# Access Compliance Report
# Public Rights-of-Way
# (Pedestrian Signals)

| ADA ID: 0A669C911D0F | Signal Type: One Push Button-Non APS | Overall Compliance: No | Severity Score: BTN 1: N/A   BTN 2: N/A   No BTN: N/A |

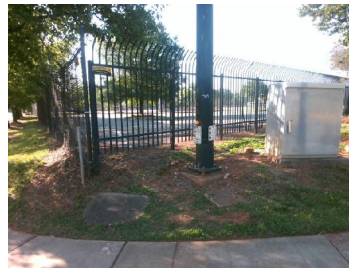
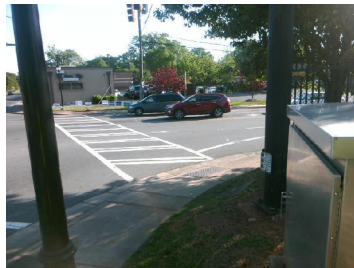
**PROW/ADA:** TMUTCD 4e.08, R404.2, R404.3, R404.7.1, R404.7.2, R406

| Compliance | Description | Data | Compliance | Description | Data |
|---|---|---|---|---|---|
| No | B 1 FWD Approach? | No | N/A | B 2 FWD Approach? | N/A |
| No | B 1 Clear Floor Space Slope (%) | 5.0 | N/A | B 2 Clear Floor Space Slope (%) | N/A |
| No | B 1 Clear Floor Space XSlope (%) | 4.3 | N/A | B 2 Clear Floor Space XSlope (%) | N/A |
| No | B 1 Height (in) | 55.0 | N/A | B 2 Height (in) | N/A |

| Compliance | Description | Data | Compliance | Description | Data |
|---|---|---|---|---|---|
| No | B 1 DistanceTo Curb (in) | 110.0 | N/A | B 2 DistanceTo Curb (in) | N/A |

**Possible Solutions:** Replace Signal Push Button With APS Button on New Post. Remove & Relocate Sign.
